LAND USE BOARD APPLICATION

**Re: Completeness Review No. 1
Minor Site Plan w/ Use Variance
Applicant: Mark Landgrebe
Block 58, Lot 7.01
44 Miller Street
Borough of Highlands, Monmouth County, New Jersey
REG File No.: HLPB25-10**

MINOR SITE PLAN
W/ 'D' VARIANCE
44 MILLER STREET
LOT 7.01 BLOCK 58
BOROUGH OF HIGHLANDS
COUNTY OF MONMOUTH NEW JERSEY

A-2

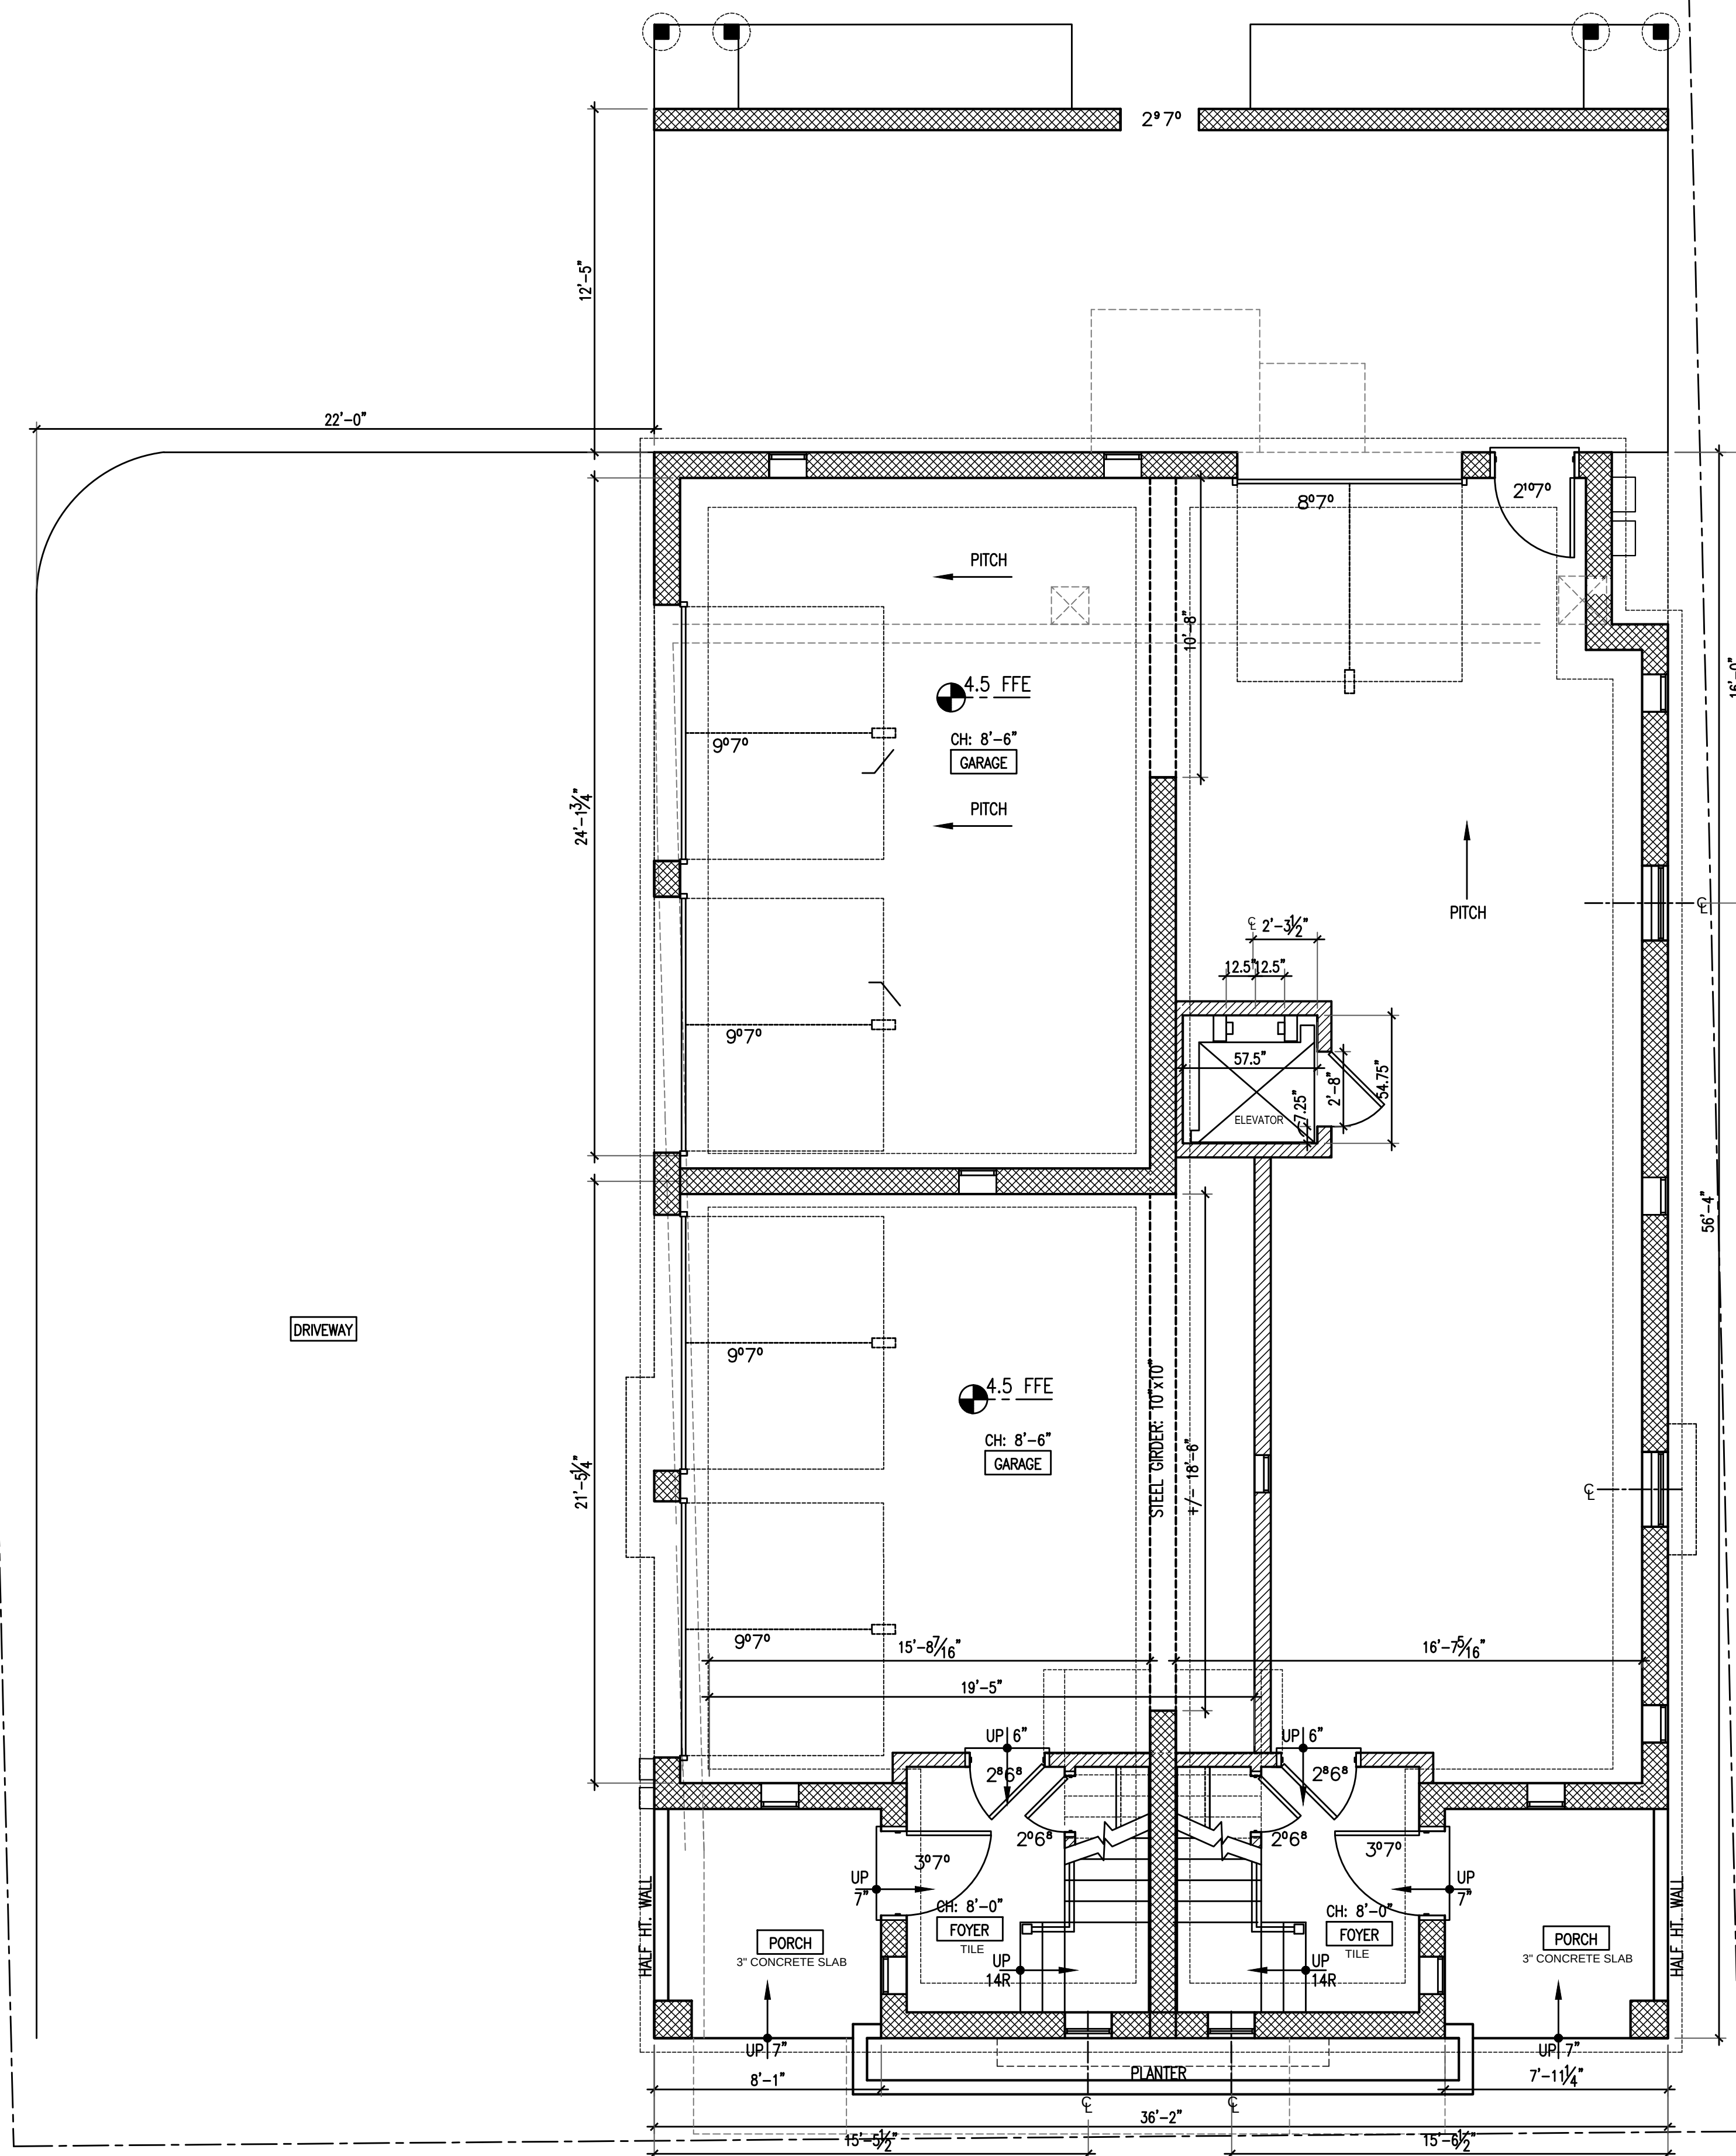
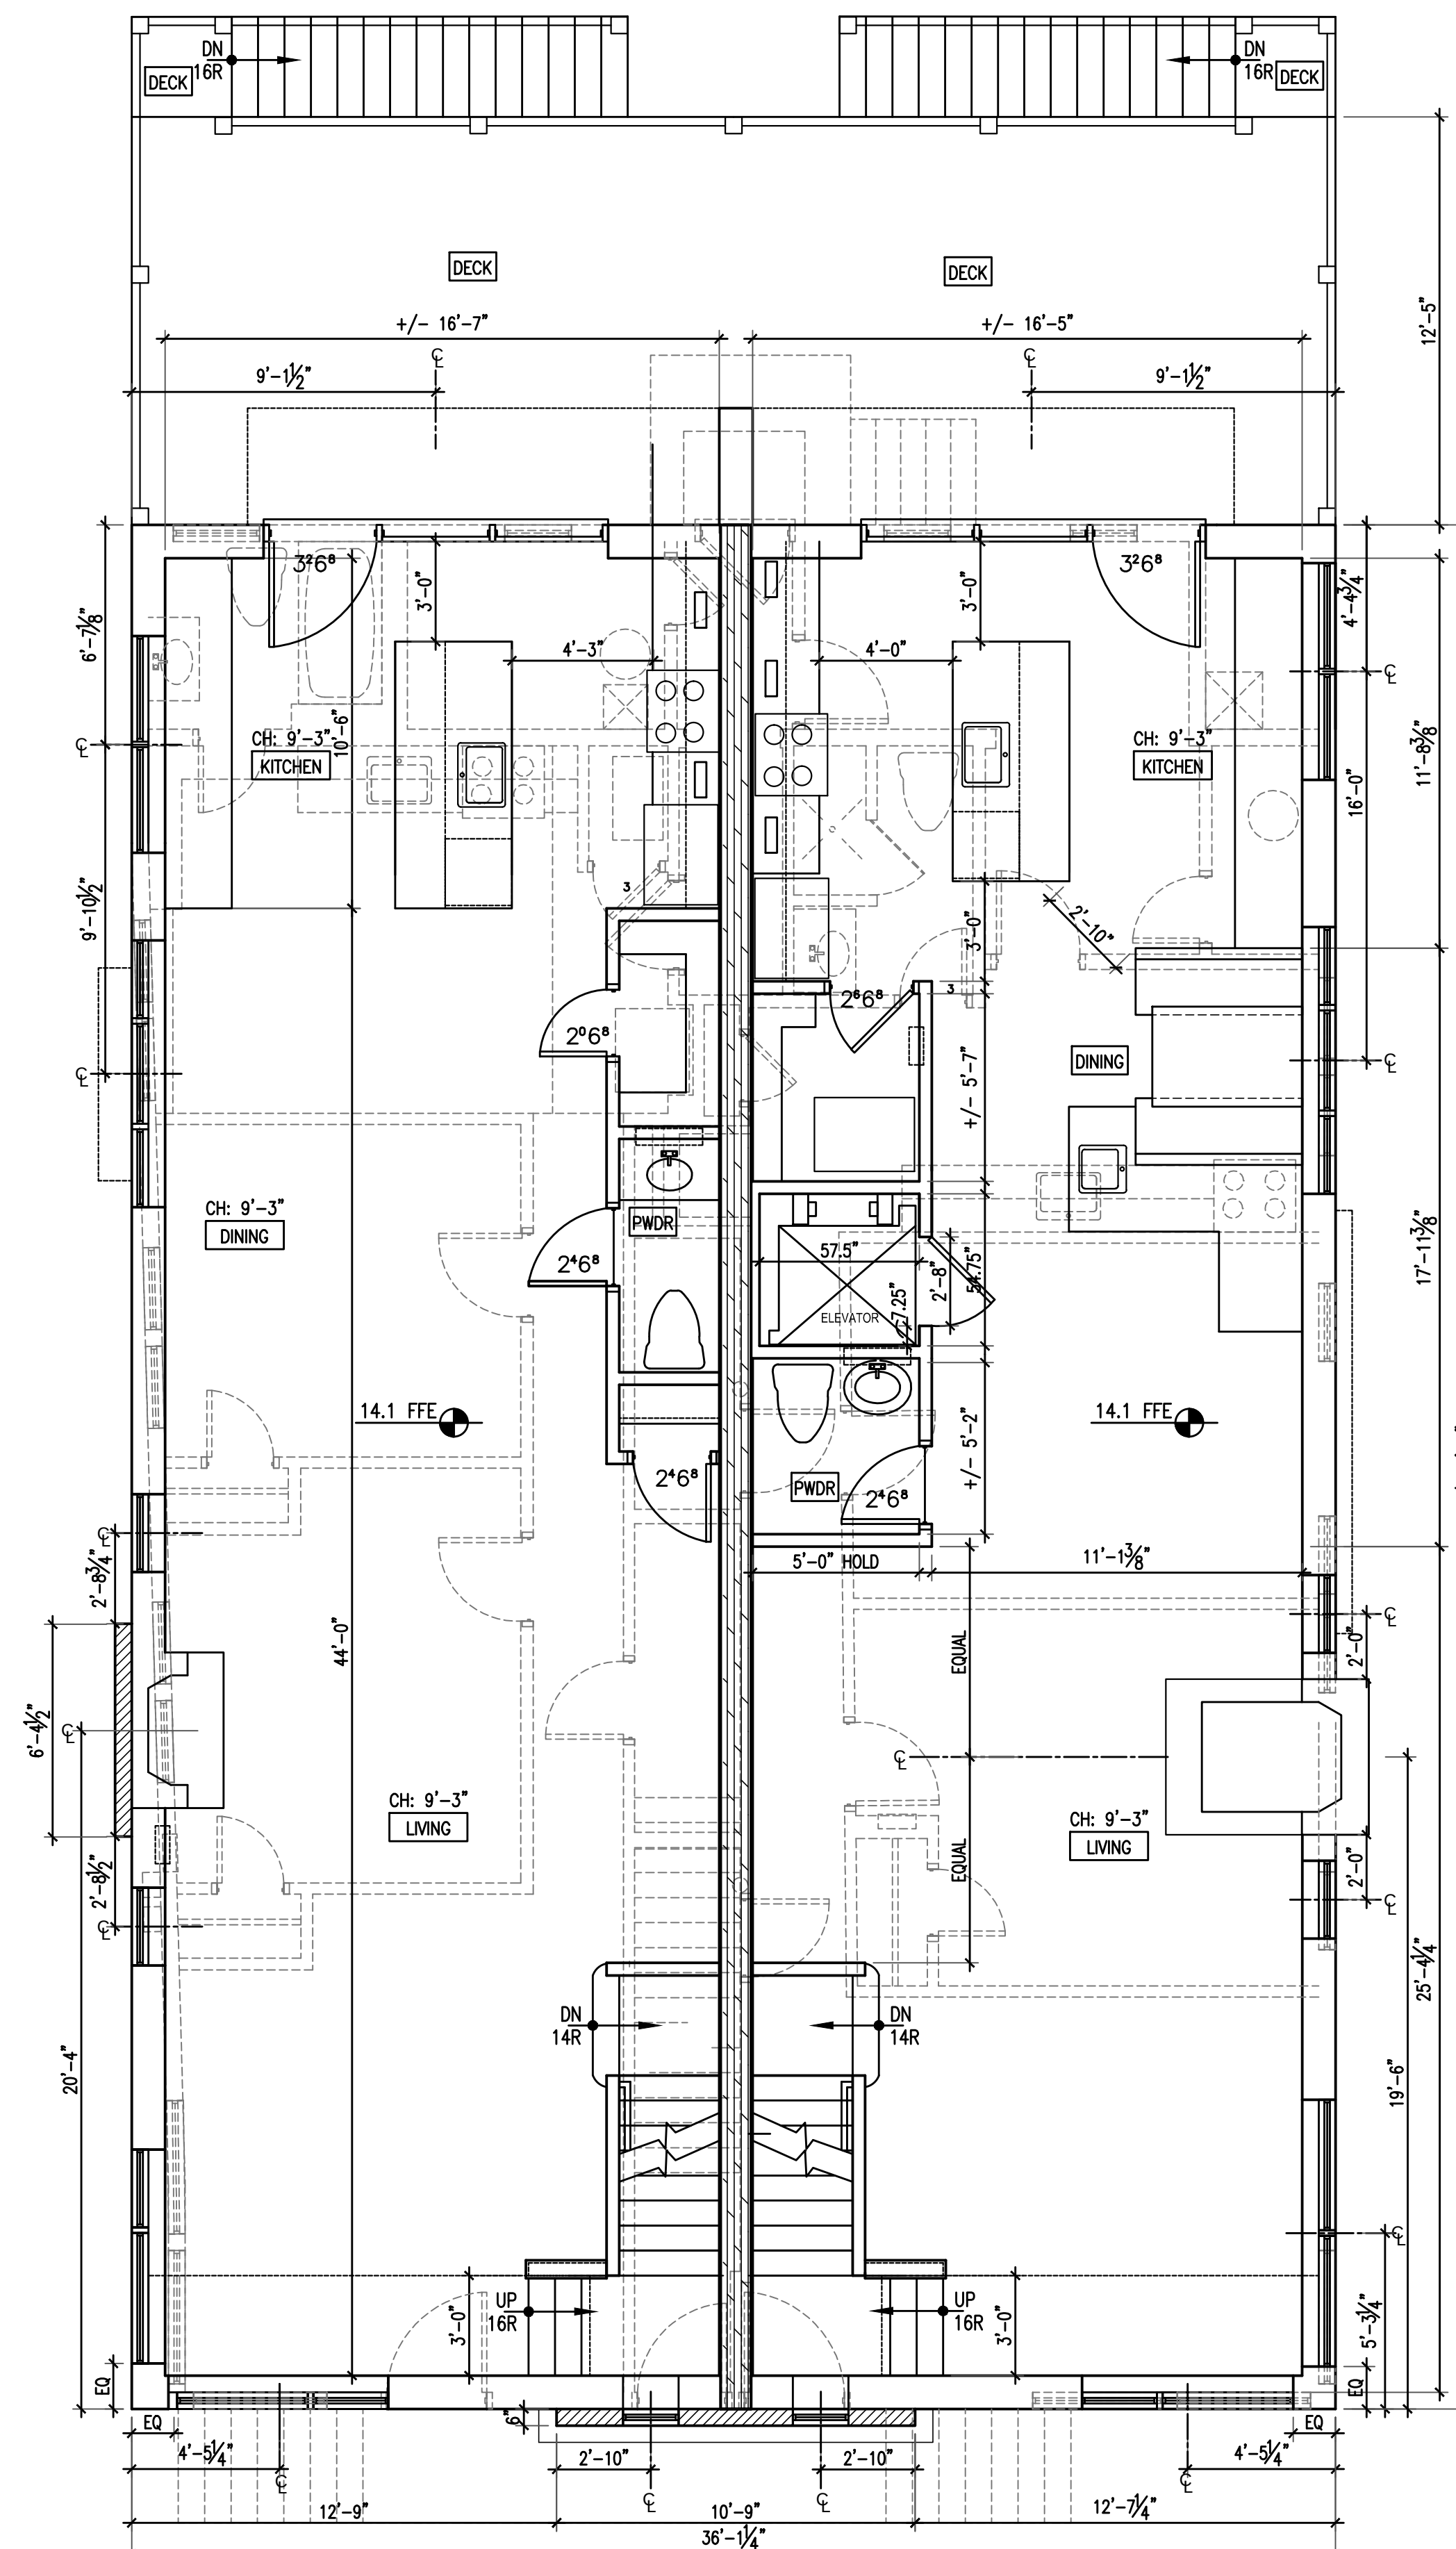
5. Please provide signed and sealed Architectural plans.
6. Please update the zoning information on the Architectural plans to be consistent with the Site Plan.
7. Please update the building height as 32'-0" and add elevations to a side section on the Architectural plans.
8. Please update the parking requirement table according to §21-65.14.C.1 Off-street parking.

Response: To be provided under separate cover.

Response: Updated Architectural plans to be provided under separate cover.

Response: Updated Architectural plans to be provided under separate cover.
